U.S. Department
of Transportation
**Federal Highway
Administration**

In Reply Refer To: HSSD/CC-88B

Name of devices: Sequential Kinking Terminal (SKT), and
Flared Energy Absorbing Terminal (FLEAT) with 2 Breakaway Posts
Type of devices: W-Beam Guardrail Terminals
Test Level: NCHRP Report 350 Test Level 3
Testing conducted by: Midwest Roadside Safety Facility
Date of request: April 22, 2008

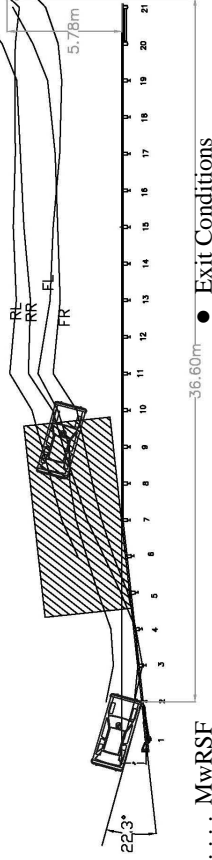
The test data summary sheets for the three recommended crash tests, FLT2P-1 (Test 3-35), FLT2P-2 (Test 3-34), and FLT2P-3 (Test 3-30) are enclosed for reference. In test FLT2P-3 there was a small hole in the floor pan caused when the nearly-stopped vehicle came to rest on the end of a guardrail post that was under the vehicle. We concur that this does not pose a significant risk to vehicle occupants. Otherwise, all occupant risk parameters of NCHRP Report 350 were within recommended guidelines. We concur that this testing shows acceptable performance for both FLEAT and SKT terminals when modified as described.
